**DEVIATION REQUEST** (Attach diagrams, figures, and other documentation to clarify request)

A deviation from the standards of or in **Section 2.3.4** of the Engineering Criteria Manual (ECM) is requested.

BIG JOHNSON DRIVE & LEGACY HILL DRIVE INTERSECTION  
TRAILS AT ASPEN RIDGE FILING NO. 2 DEVIATION EXHIBIT  
FEBRUARY, 2020

**PLAN**

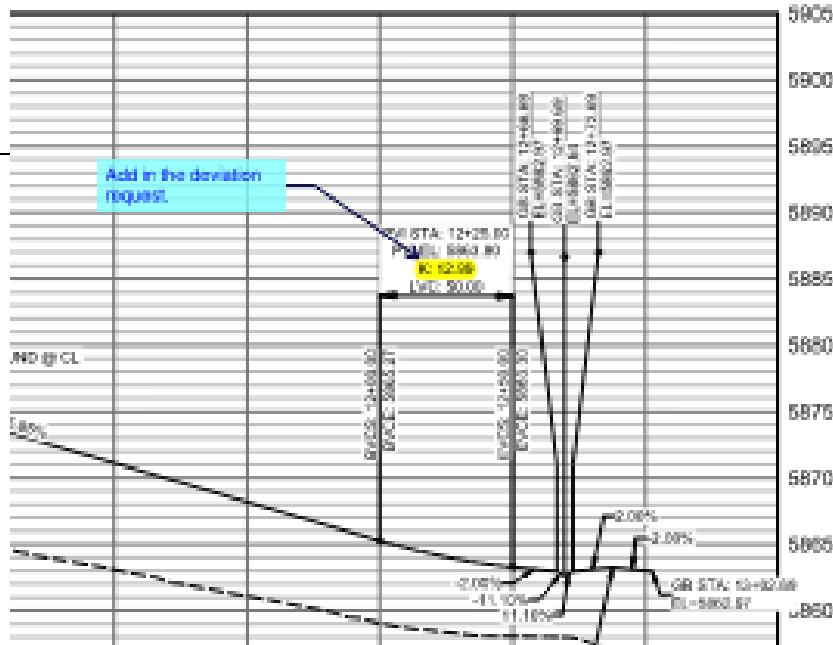
Add in the deviation request.

Add Bear Track & Bird Ridge intersection to the deviation request.
